From: pharrington@lowerchurchillproject.ca
To: jamesmeaney@nalcorenergy.com
Cc: [Auburn Warren](#); [Derrick Sturge](#); [Gilbert Bennett](#); [Lance Clarke](#); [Peter Madden](#); [Rob Hull](#); [Martis Xeno](#)
Subject: Re: URGENT: Canada/CBB Memo for Nik/MWH on IE Report
Date: Wednesday, November 20, 2013 12:15:32 PM
Attachments: [_ong](#)
[20131120120126.pdf](#)

Subject: URGENT: Canada/CBB Memo for Nik/MWH on IE Report

MUSKRAT FALLS GENERATING STATION AND LABRADOR TRANSMISSION ASSETS

Figure 4-2 LCP Organization and Governance⁴

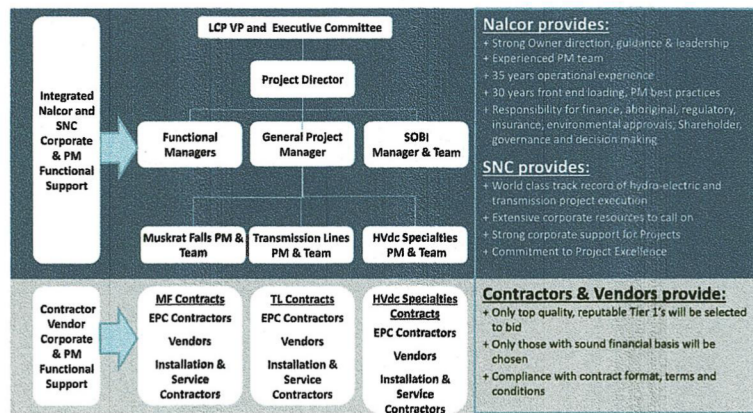
This section is redundant. Since we have adjusted the organizational model, which MWH endorses.
